pd-trigger — Design Document

ai-ee v1 pipeline

Board review (P8 adversarial) - pd-trigger

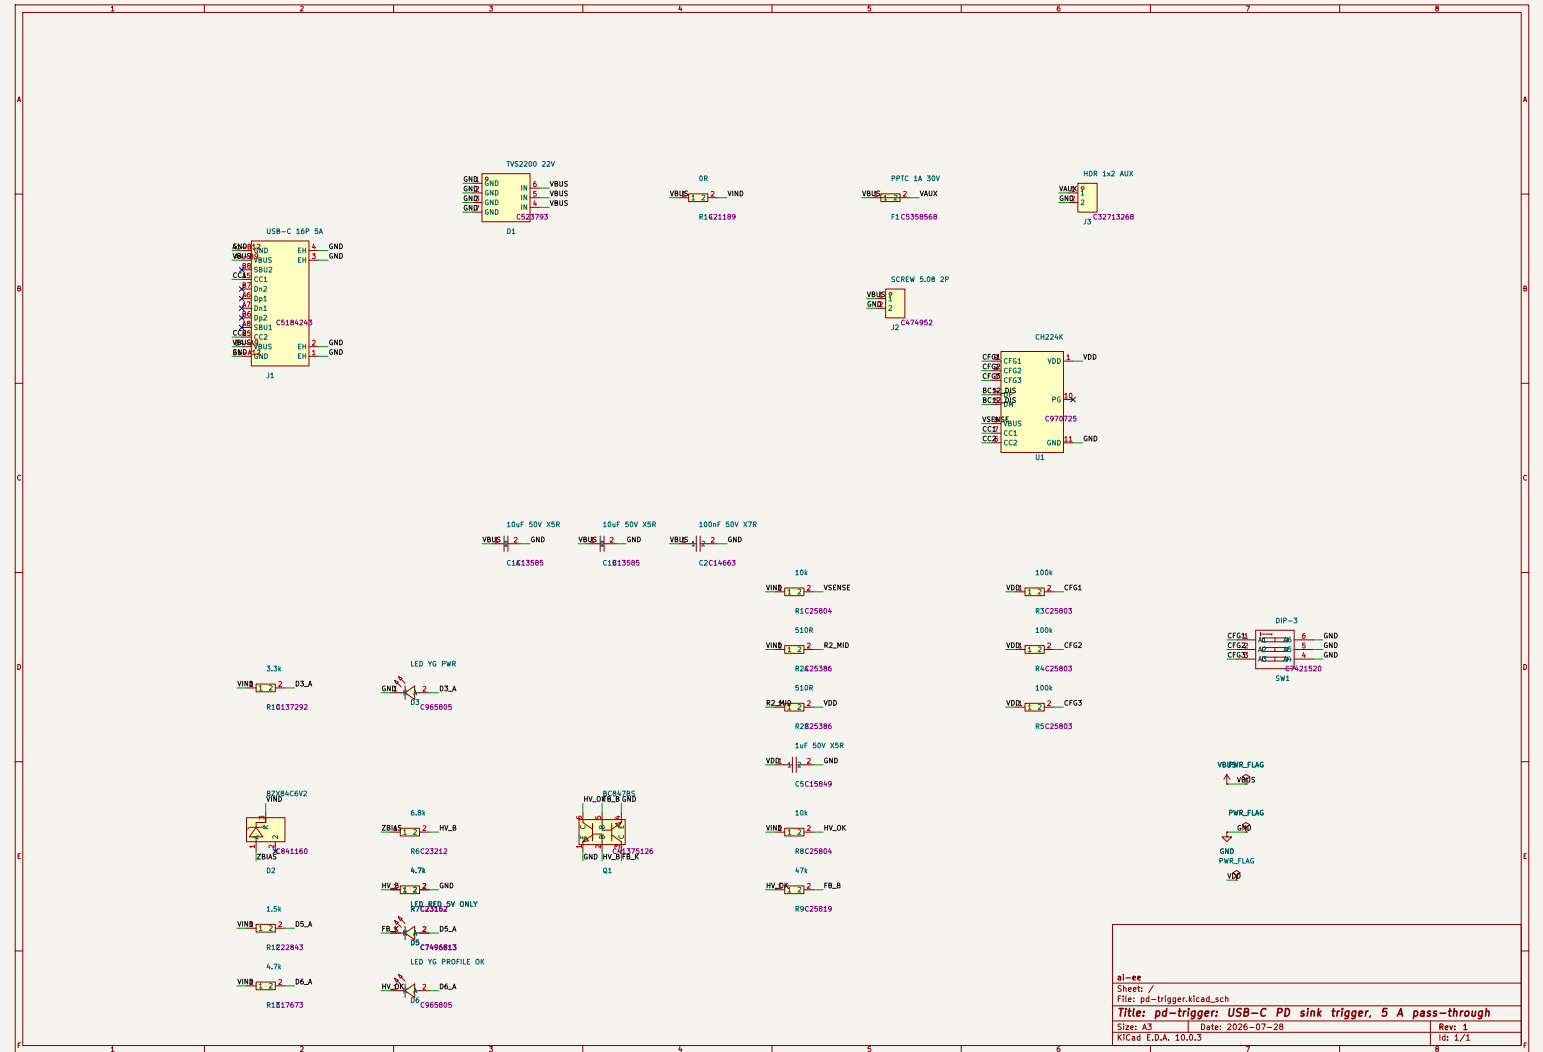
W1 dp-dm-short-at-chip: architecture's PD-only short (/BC12.DIS) ACCEPTED by the reviewer as hardware-SAFER than the datasheet's connector wiring (removes a 21V-onto-3.8V-abs-max fault path). Cost: no QC/BC legacy support - the board is "PD sources only"; goes on B.SilkS + order docs. W2 vdd-worst-corner: true worst case 0.979mA at 4.4V low-line all-straps- closed vs unpublished CH224K IDD - bounded by WCH's own reference circuit; V1 bring-up step: measure VDD at the 5V profile; contingency = both 510R -> smaller (documented floor 600R total). Bring-up addenda: buzz out Q1 E/B/C once (clone PDF JS-gated; Nexperia- standard pinning verified as the compatibility claim).

reports/render_final/top.png

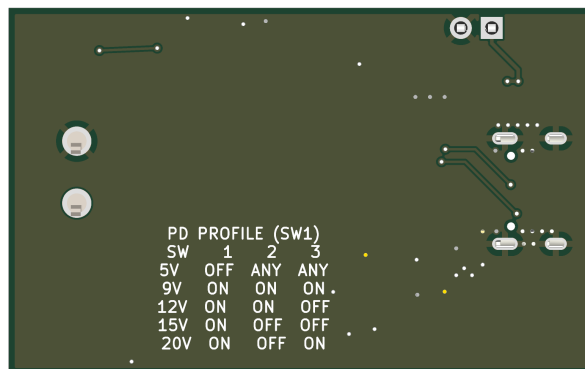
E1 - 5 A return chokes at J1's GND contact pads (error, checker-blind by design D7)

The 4 GND cable contacts land on two merged SMD pads (F.Cu only): A1-B12 at (17.63,39.31) and B1-A12 at (17.63,45.71), nominally 2.5 A each at the 5 A rating. Their ONLY copper into the B.Cu return pour:

- A1-B12 (top): a 0.2 mm wide, 2.7 mm long F.Cu chain (3 segments) into shell pad 1's THT barrel, plus one 0.6/0.3 via whose annulus grazes the pad corner by ~0.05 mm (etch-tolerance-level). 0.2 mm at 2 oz = 0.80 A capacity at 10 C rise (pipeline model); at 2.5 A the same model gives ~133 C rise (short-neck heatsinking will moderate this, but it is a >3x overcurrent on the model's own terms). ~13.6 squares = 3.3 mohm.
- B1-A12 (bottom): a 0.2 mm x 1.3 mm trace into ONE 0.6/0.3 via. The board's own via budget (constraints via_amps 0.5) says 2.5 A needs 5 vias; there is 1. Shell pad 4 sits 0.32 mm away but is NOT connected on F.Cu - its copper does not help.

Architecture D7/power_tree structural requirement ">= 10 vias at J1's GND pads" (the stated substitute for keeping GND out of power[] so check_current stays quiet): not delivered. DRC cannot see it (0.2 mm is netclass-legal), check_current cannot see it (GND undeclared), check_return_path no-ops (no high_speed key). Failure mode: sustained 5 A at any profile heats the two necks far past the 10 C design intent; long-term trace/joint fatigue, intermittent ground, and full return current cascading onto the surviving 0.2 mm chain. Fix is cheap at P9: an F.Cu GND spandrel bonding each contact pad to its shell pad (the VBUS pour top edge is at y 39.7 - the strip above it, and the strip x < 17.2 plus the region south of y 46, are free) plus 4-5 vias per side.

E2 - Safety/waiver silk markings absent (error, promised artifact) Board-wide gr.text count is ZERO; B.SilkS carries nothing at all (both B.SilkS references in the file are the stackup layer table). Missing, each one a written promise:

- AUX 1A MAX + V+/GND at J3 (P0 answer 4 "silk-marked", V10). F1 makes overload safe-by-hardware, but polarity of the 2-pin aux header is unmarked.
- PD SOURCES ONLY (ERC waiver W1's standing condition: "goes on B.SilkS + order docs"). The waiver's silk half is currently unfulfilled.
- J2 screw-terminal polarity. Trunk lands on J2 pad 1 = the LOWER screw (board-bottom side); nothing anywhere tells the bench user which screw is V+. Reverse-wiring a load on a 100 W output is the single easiest field mistake this board can cause.

E3 - User-interface silk absent (error, promised artifact)

- The five-row profile table on B.SilkS - D3 calls silk "the user interface" and specifies the table verbatim; the bottom is a clean pour with room. Without it the ON/OFF-to-voltage map exists only off-board; a user WILL set 9 V expecting 12 V by trial and error. (Fail-safe floor: any wrong guess >= the 5 V fallback, and OFF-fail = 5 V - the mistake is bounded but real.)

- LED legends PWR / 5V ONLY / PROFILE OK (D4/V10): the render shows refdes D3/D5/D6 only. The entire P0-answer-6 "visible fallback indication" scheme is mute without the words - a lit red LED labeled "D5" indicates nothing.

- PRESENT and correct: SW1's own footprint prints ON + 1 2 3 (the compact F.SilkS marker D3 asked for) - confirmed on the top render.

W1 - J1 mouth recessed ~0.4-0.5 mm behind the board edge (warning, flagged at P6) Courtyard/silk front edge $x = 10.18$ vs board edge $x = 9.8$. USB-C receptacles are normally flush-to-overhanging; a recessed mouth lets thick/molded plug overmolds butt the board edge and hold the plug fractionally short of latch - intermittent CC, no PD, "works with some cables". On a bare bench board with arbitrary cables this is a real annoyance risk. Fix: nudge J1 -x 0.5-1.0 mm at P9 (pour edge follows; nothing else in that corridor), or accept and note in order docs.

W2 - Outline 48 x 30 mm exceeds the architecture's hard ceiling (warning, drift) Edge.Cuts = (9.8,27.51)-(57.8,57.51) = 48 x 30 mm. D9: nominal 45 x 25, "hard ceiling 48 x 28 mm"; 30 mm violates D9's own ceiling by 2 mm even though it equals P0 answer 5's literal +20 % (40x25 -> 48x30, +44 % area vs the brief's target). No digest discloses the growth past D9. Consequence is cost/footprint only, but it must be disclosed to the user at the checkpoint rather than discovered.
